Groundwater Application Review Summary Form

Application # G- 19007

GW Reviewer Travis Brown Date Review Completed: 12/24/2020

PUBLIC INTEREST REVIEW FOR GROUNDWATER APPLICATIONS

Well Statistics – T4S/R1E-S25, 26, 35, 36

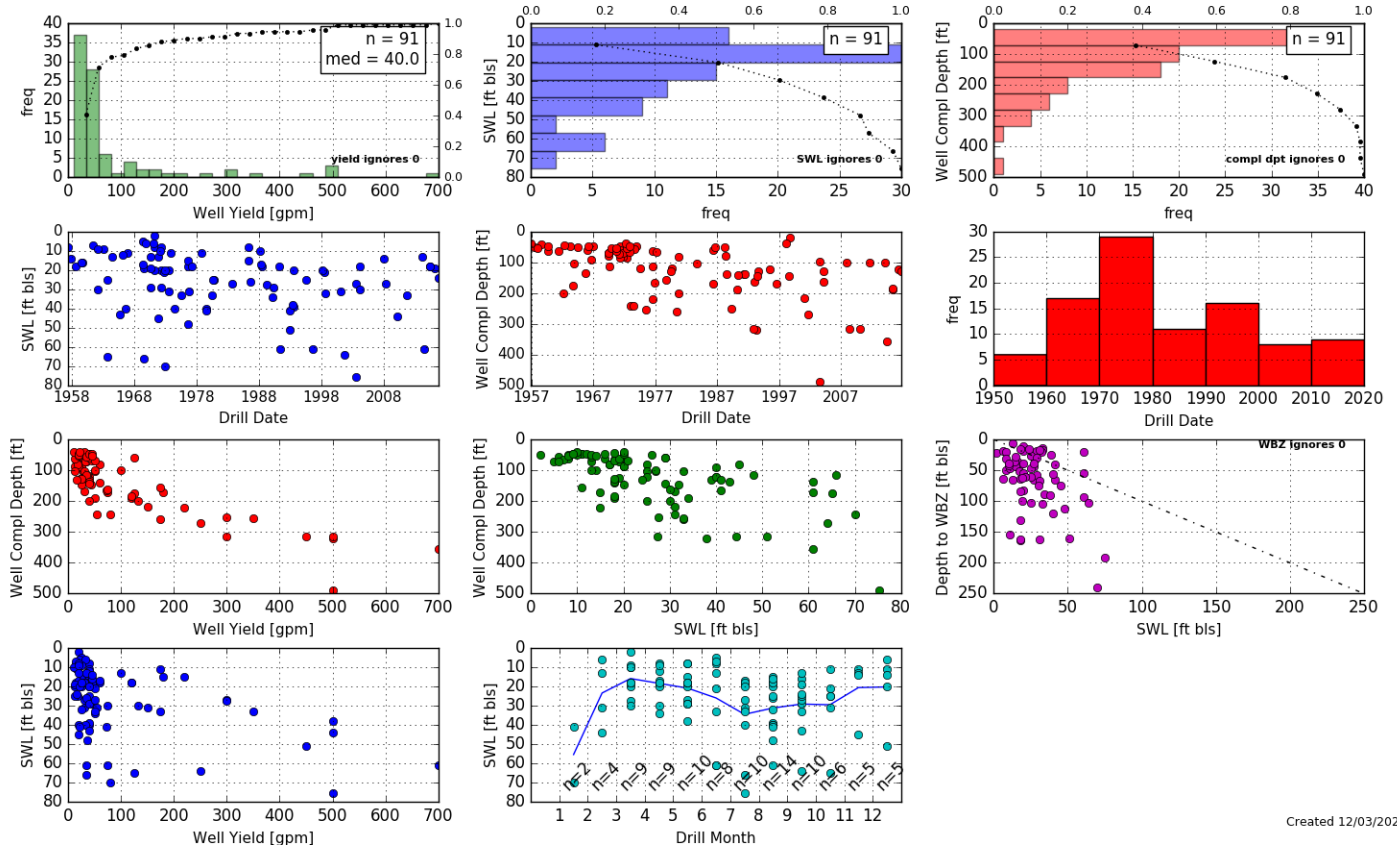
Basis for aquifer confinement evaluation: Reported water levels in nearby wells are predominantly above the applicable water-bearing zones (see attached Well Statistics). Additionally, groundwater mapping in this area indicates water levels are above the estimated top of the coarse-grained Willamette aquifer sediments (Woodward et al., 1998). The available evidence indicates the proposed aquifer is confined.

Hydrograph

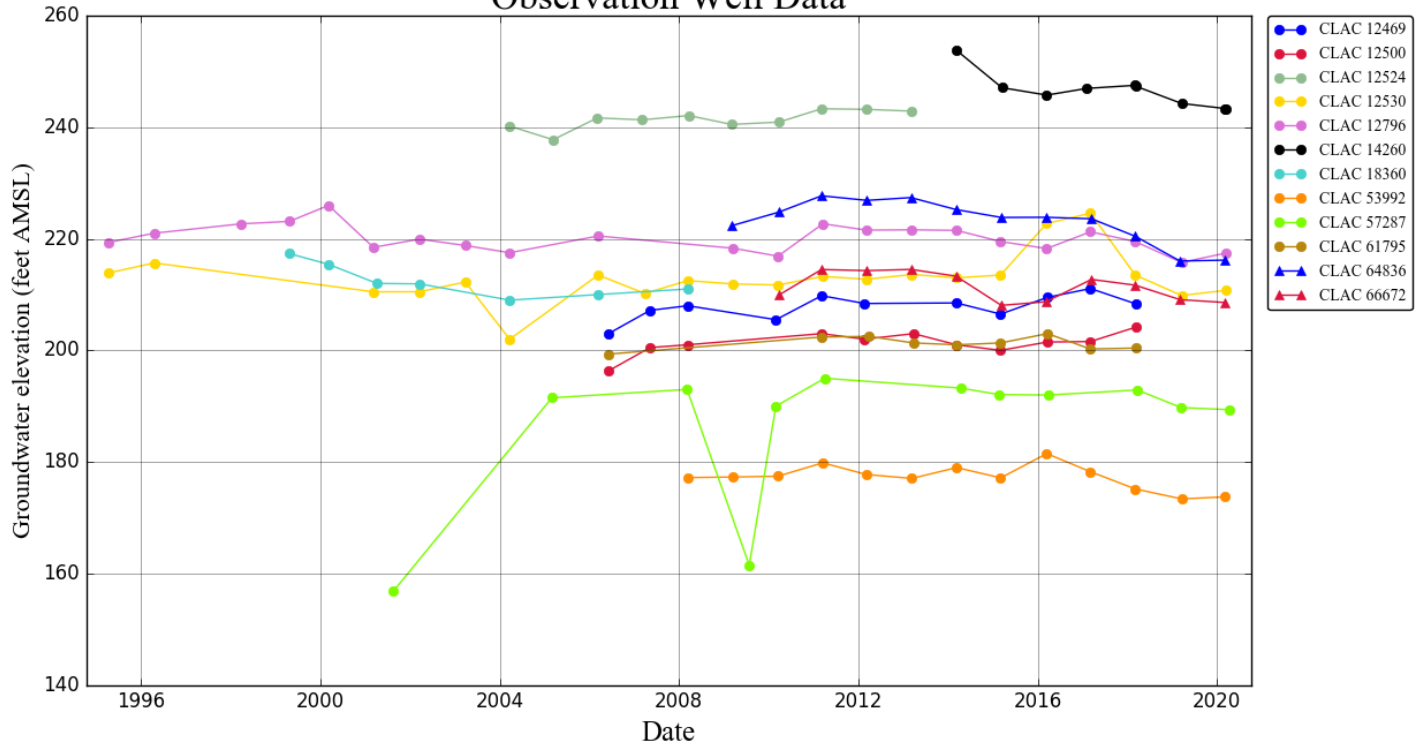
The proposed POA would produce groundwater from the alluvial aquifer system. Nearby well logs generally indicate ~20-60 ft of water-bearing sand and/or gravel beginning at ~40-90 ft below land surface (bls). However, mapping by Gannett and Caldwell (1998) indicates the thickness of the Willamette Aquifer (coarser grained sediments) as greater than 120 ft in the area of the proposed POA, with 20-40 ft of overlying fine-grained sediments (the “Willamette Silt”). The applicant’s proposed total depth (400 ft) for the POA is greater than the majority of wells in this area (see attached Well Statistics). The proposed POA would likely be partially completed in the predominantly fine-grained “Willamette Confining Unit” (Gannett and Caldwell, 1998). Deeper wells in this area have generally reported higher yields, and the applicant’s combined requested rate (0.516 cfs / ~232 gpm) is less than the median yield (275 gpm) reported for wells deeper than 200 ft bls (see attached Well Statistics – Wells >200 ft bls). Water levels measured in nearby wells are generally very stable (see attached Hydrograph).

Well Interference Analysis

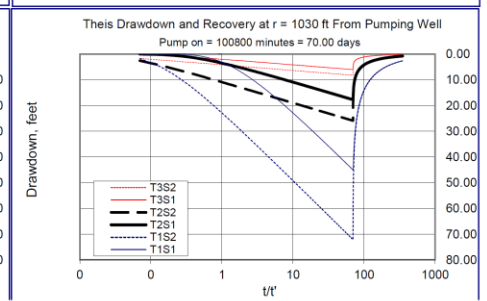
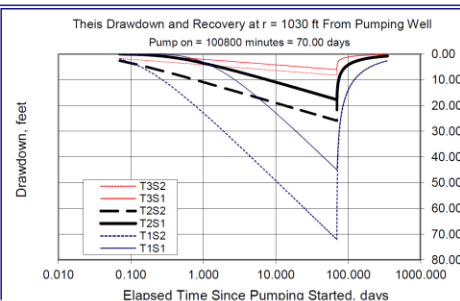
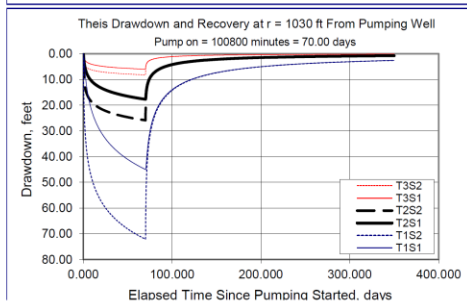
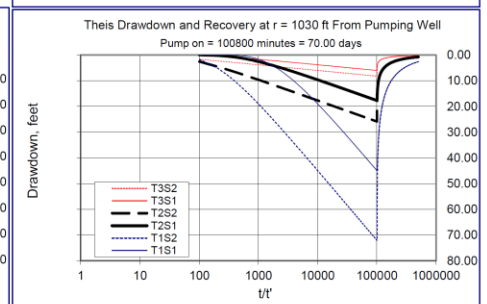
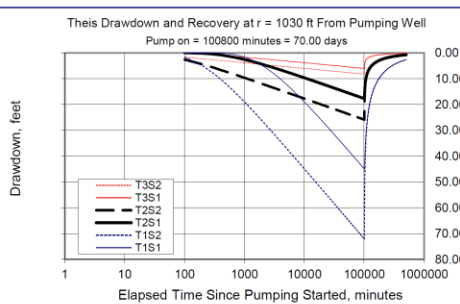
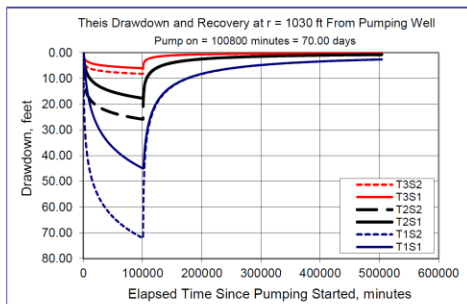
The nearest neighboring well to the proposed POA is CLAC 56632, ~1,030 ft north of proposed POA Well 1. CLAC 56632 is reportedly completed to ~171 ft bls. Interference with CLAC 56632 was quantitatively estimated using the Theis (1935) equation for drawdown in a confined aquifer. Hydraulic parameters used for the analysis were derived from regional data and studies (Pumping Test Reports; Conlon et al., 2003, 2005; Iverson, 2002; McFarland and Morgan, 1996; Woodward et al., 1998) or are within a typical range of values for the given parameter within the hydrogeologic regime (Domenico and Mifflin, 1965; Freeze and Cherry, 1979; Halford and Kuniansky, 2002). At a combined rate of 0.516 cfs, the proposed use is unlikely to cause interference with CLAC 56632 or similarly located wells which would meet the definition of injury (see attached Well Interference Analysis).

The conditions specified in Item B1(d) and B2(c), above, are recommended for any permit issued pursuant to this application.
